Re: **Response to IDEM's November 1, 2012 Review of Additional Investigation Activities Report, Geophysical Survey Investigation Report, and Request for Revised RWP Approval and Technical Response to General Notice of Potential Liability Review**
Michigan Plaza
3801-3823 West Michigan Street
Indianapolis, Indiana 46222
IDEM VRP #6061202
MUNDELL Project No. M01046

Figure 2. Sewer Line for Floral Park Cemetery

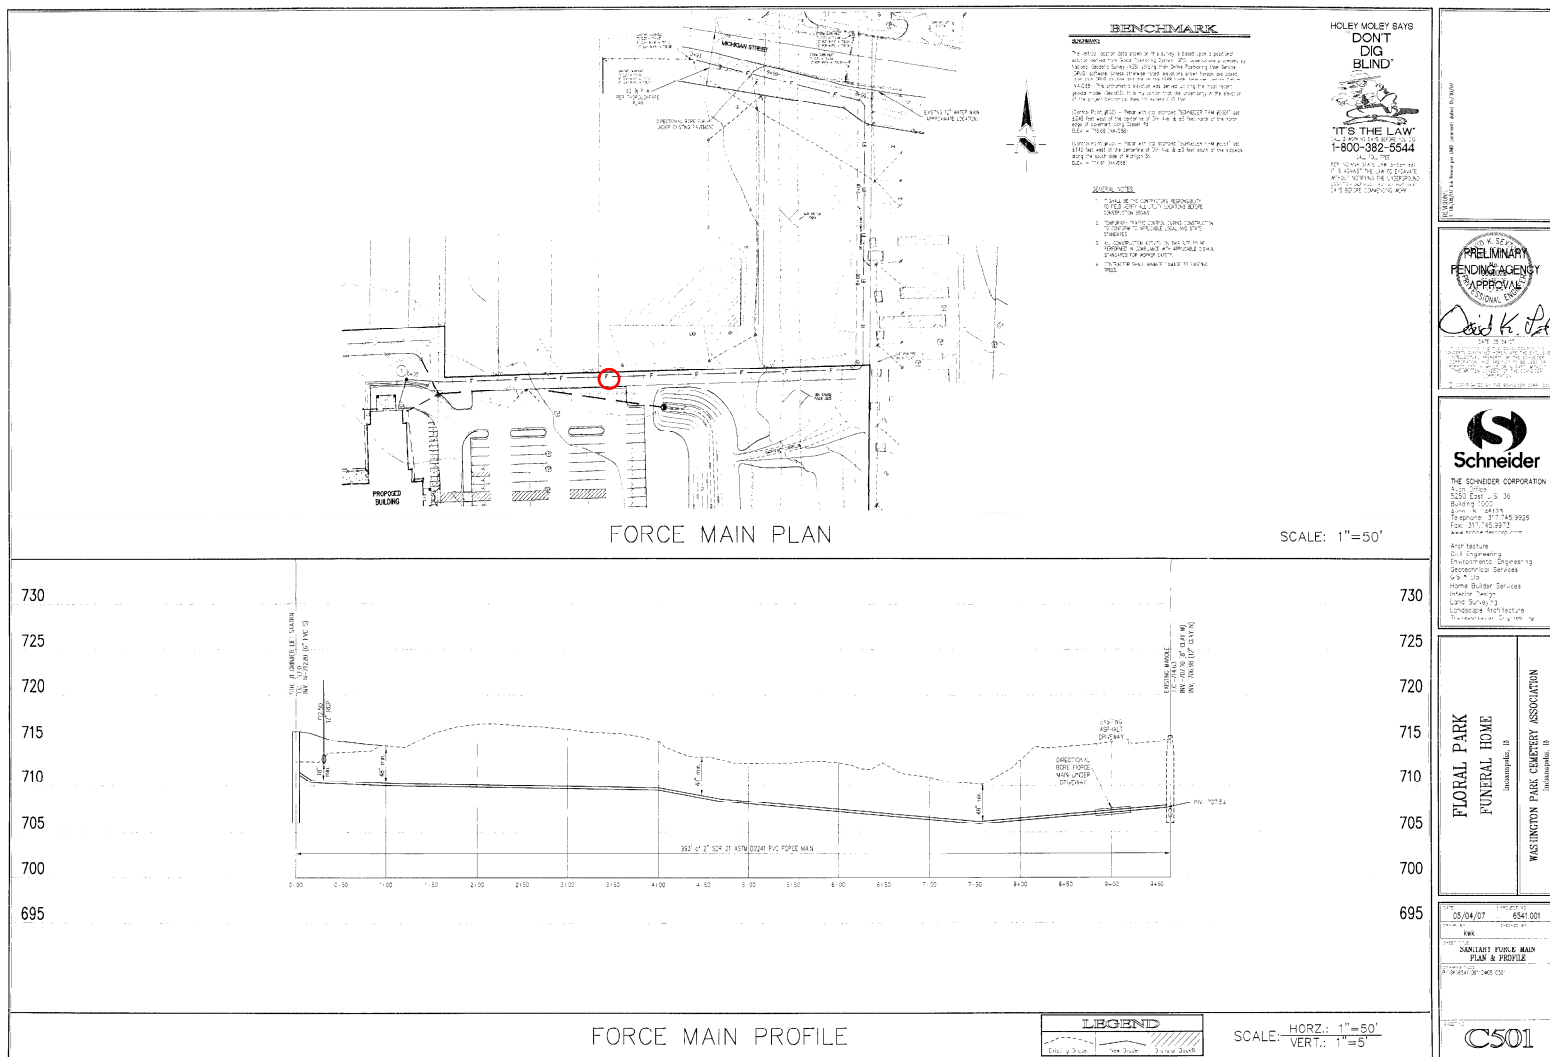
IDEM Comment No.1. *“According to page six of this report, during the installation of monitoring well MMW-P-11D a private forced sewer line with an associated private lift station was encountered approximately three feet bgs. The report indicates that as-built drawings were provided by the City of Indianapolis, however the location of the line was not depicted on any site maps. Preferential pathway releases are a primary contaminant source for Michigan Plaza. As such, it is imperative that a diagram of this sewer line be provided as well as a depiction of where it discharges. IDEM also requests that the as-built drawings from the City of Indianapolis be submitted for review.”*

Please see the attached **Figure 2**, which provides a map of the sewer line from the Floral Park Cemetery. As indicated on the figure, the sewer line is aligned east-west along the northern edge of the Floral Park parking area exiting the cemetery main building. Once it goes beyond the western edge of the Michigan Plaza property, it heads north until it approaches Michigan Street, and then heads west to tie into the manhole of the Michigan Plaza sewer line just before it crosses Michigan Street to the north. MUNDELL observed the construction of a portion of this sewer during the summer of 2007. As indicated from the map, the invert elevation for the forced main is between EI 705 and 710. The boring log for MMW-P-11D shows that the native material at the depth of the forced main is sand and thus there would be no appreciable difference in hydraulic conductivity between any backfill and the native materials. The potentiometric surface maps for this area shown the water table to be at around EI 696, or at least 10 ft below the sewer invert. Therefore, there is no preferential pathway caused by the construction of the sewer. Again, this sewer was installed well after early observations of vinyl chloride in MW-170D. The potentiometric surface maps for this shallow groundwater in this area have also consistently shown a south-southeastern direction of groundwater flow, which would not allow for any groundwater pressure to cause redirected flow back to the west.

FIGURE 10B.
MICHIGAN PLAZA AND MEADOWS APARTMENTS
CONCEPTUAL SITE FLOW MODEL DEEP UPPER SAND AND GRAVEL

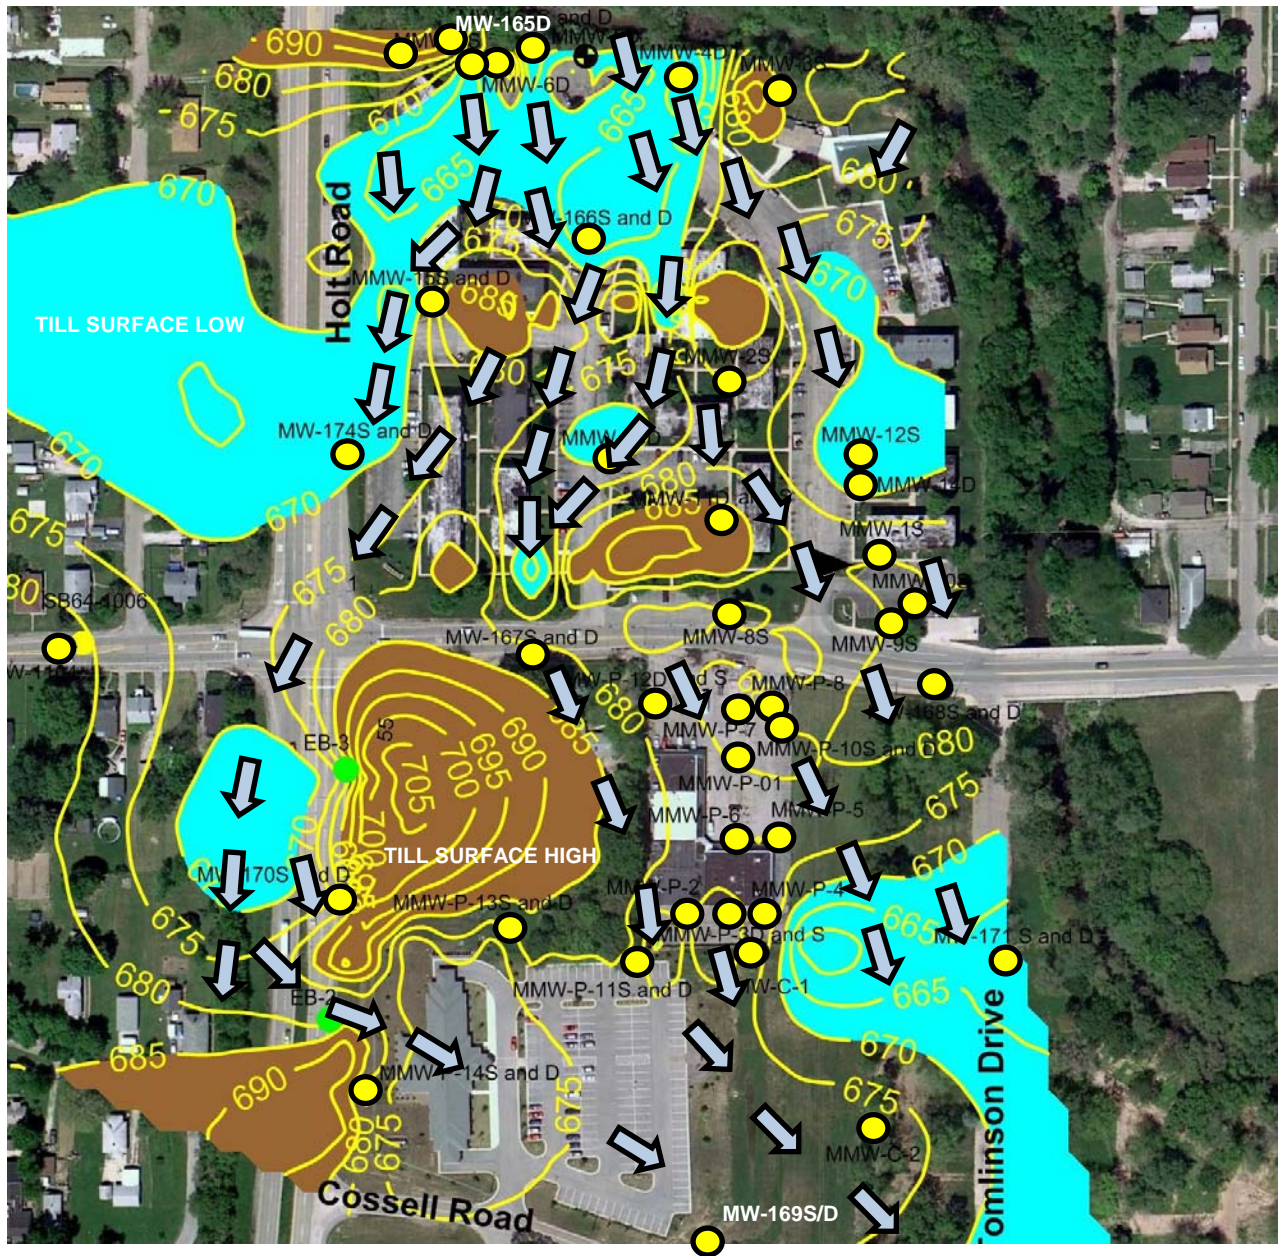
In summary, the cis-1,2-DCE and vinyl chloride plume maps (Figures 15-18) depict unusual shapes without accessible analytical data to support them. A complete listing

of each groundwater data point used to create composite map should be provided. Furthermore, the maps should be revised to accurately depict the supporting analytical data. Without this data, the interpretation of the plumes nature and extent is unsupported."

See MUNDELL Response to IDEM Comment 6a. MUNDELL does not believe that the plume maps depict 'unusual shapes' based on the analytical data used, the existing geologic conditions in the area, the concentrations of cis-1,2-DCE and Vinyl Chloride still coming onto the Michigan Meadows Apartment Site from the north, and the potentiometric surfaces of the shallow and deeper sand and gravel (as seen in Figures 16 and 17 in the March 12, 2012 AIASR). In fact, the distribution of cis-1,2-DCE and VC are remarkably consistent with all of this data and the conceptual site groundwater flow model depicted in **Figure 10B**.

FIGURE
15R

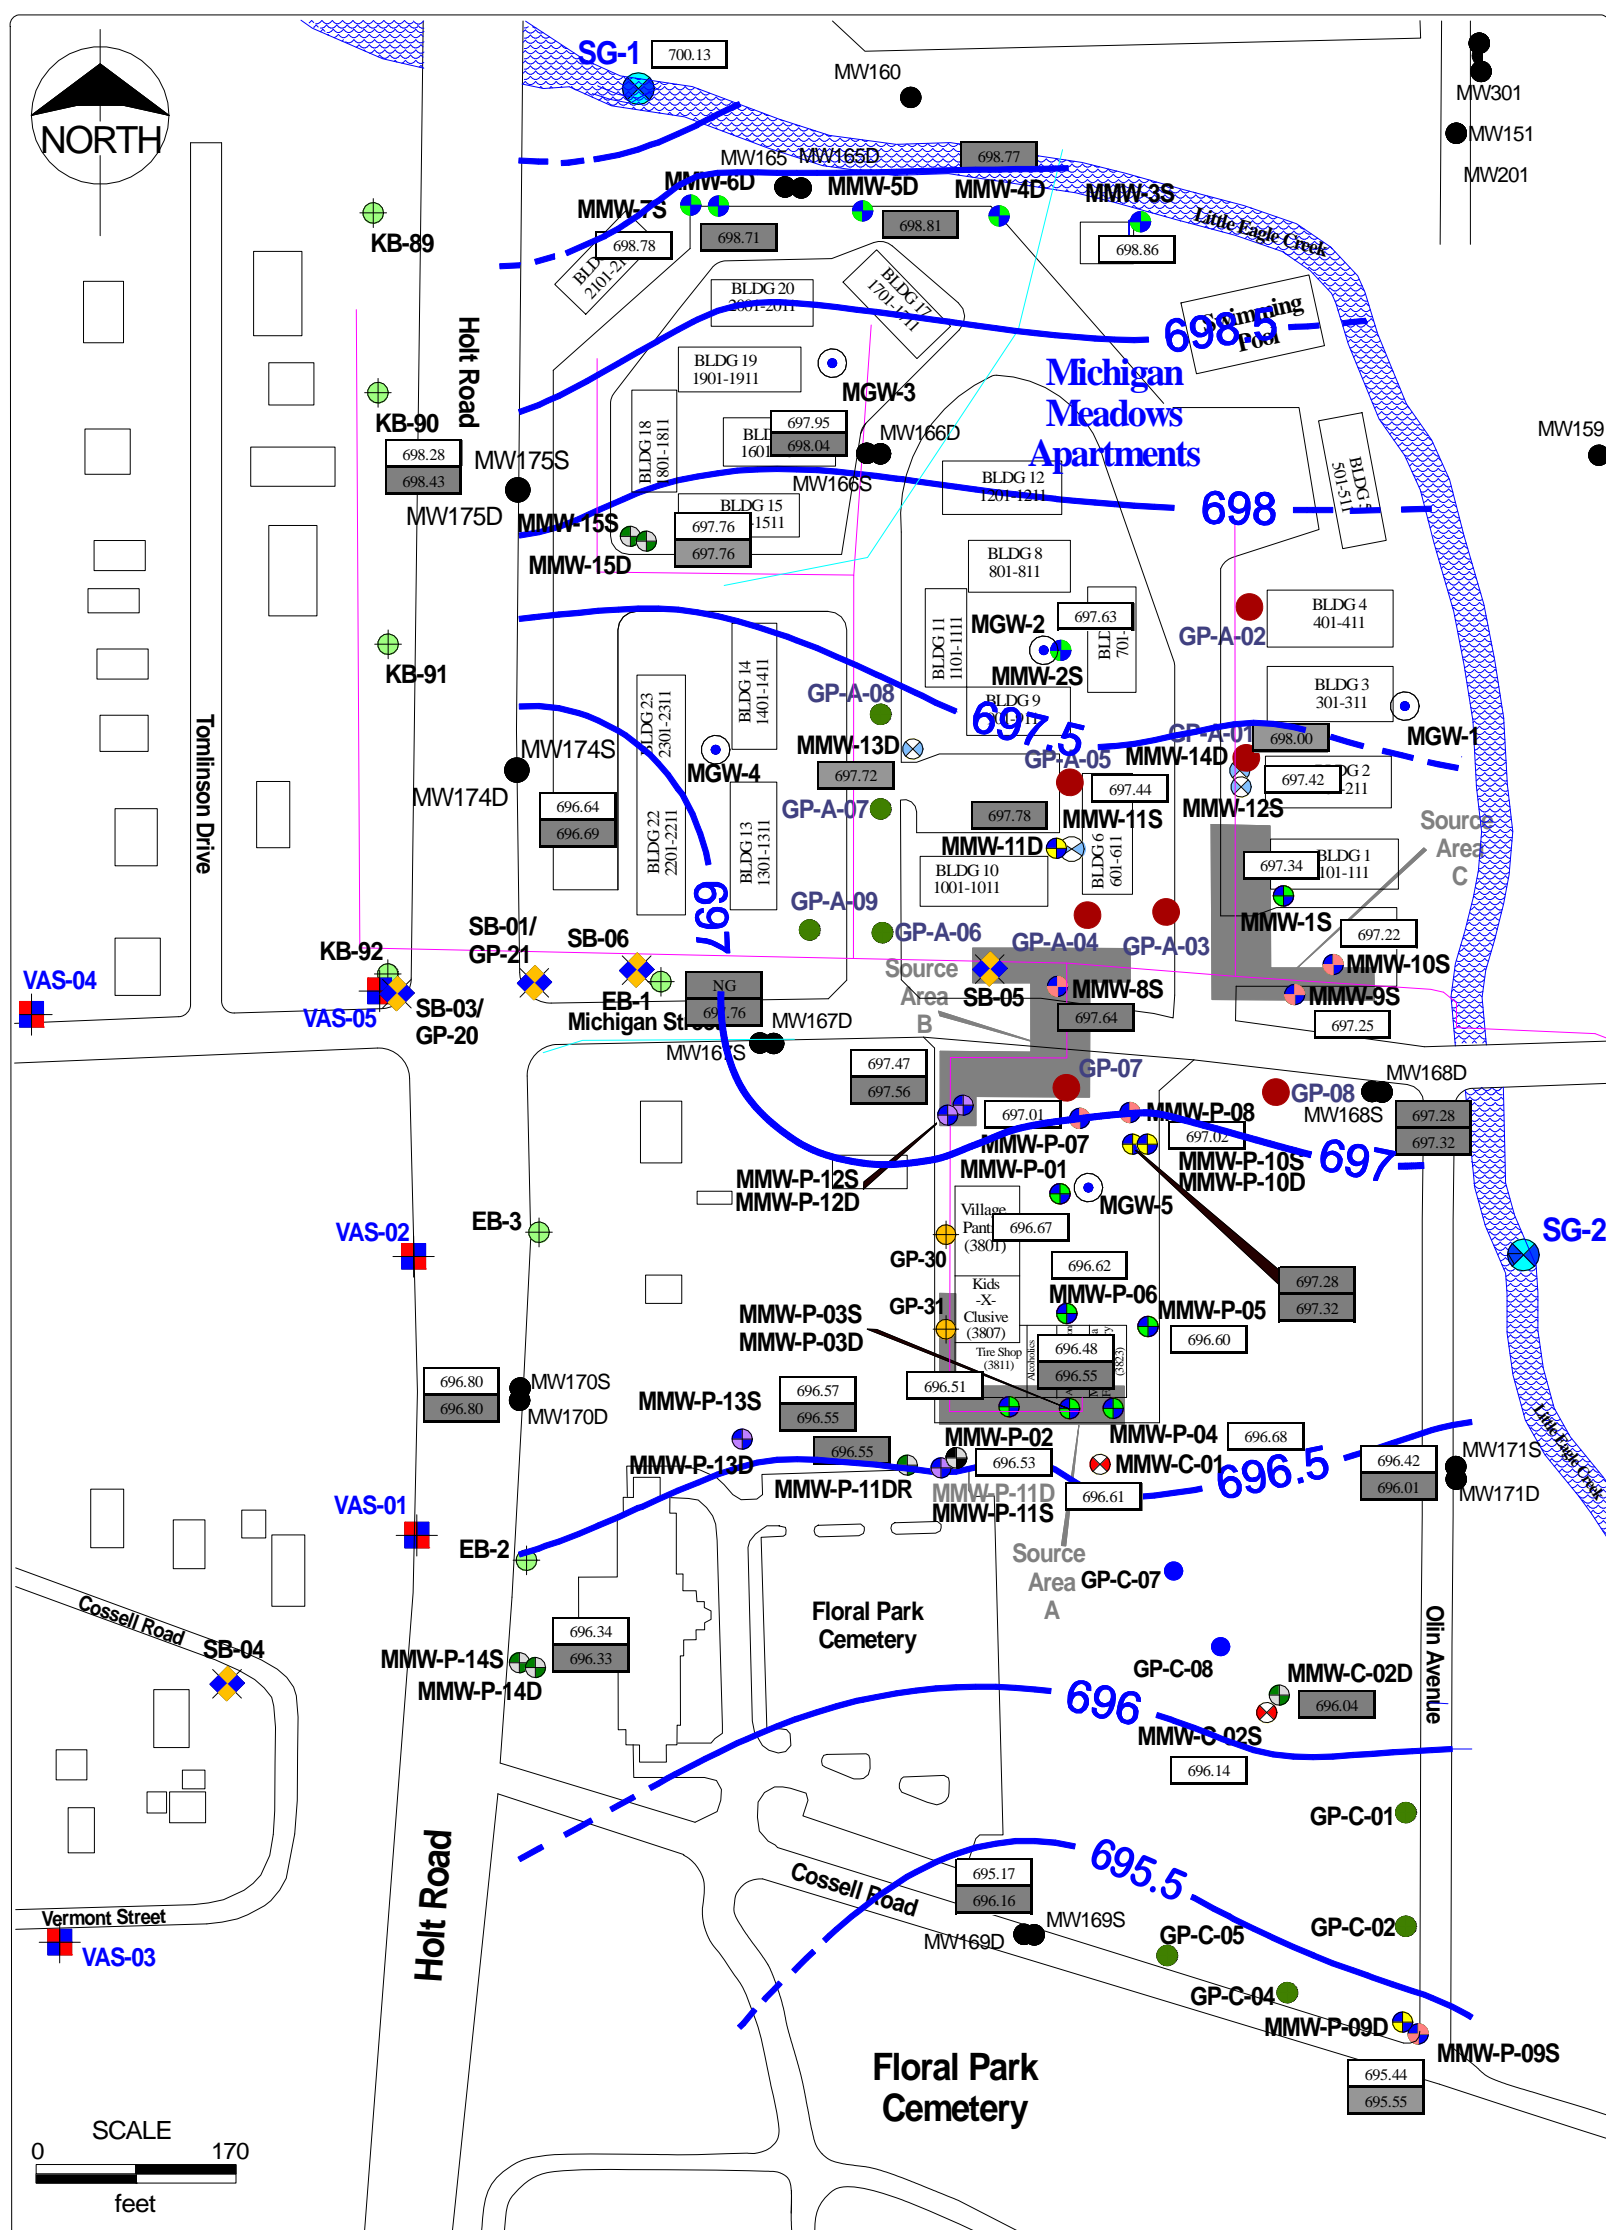
- *Figure 15 – Cis-1,2-DCE Distribution in Shallow Groundwater: The figure depicts monitoring well MW-167S as being located within the >10 ug/L contour. A review*

of the sampling data for this well indicates that for the past two years the well has been below detection limits for cis-1,2-DCE."

MUNDELL agrees that the concentration in MW-167S has been below detection limits for cis-1,2-DCE during the last two years, and the contour map should have reflected this concentration. A *Revised Cis-1,2-DCE in the Shallow Groundwater Map* is provided in the attached **Figure 15R**. As indicated in the figure, the only change from the previous **Figure 15** is a lower cis-1,2-DCE concentration area present north and northwest of the Plaza highlighted in 'white/yellow' which includes monitoring wells MMW-2S, MMW-8S, MW-167S and soil boring SB-05.
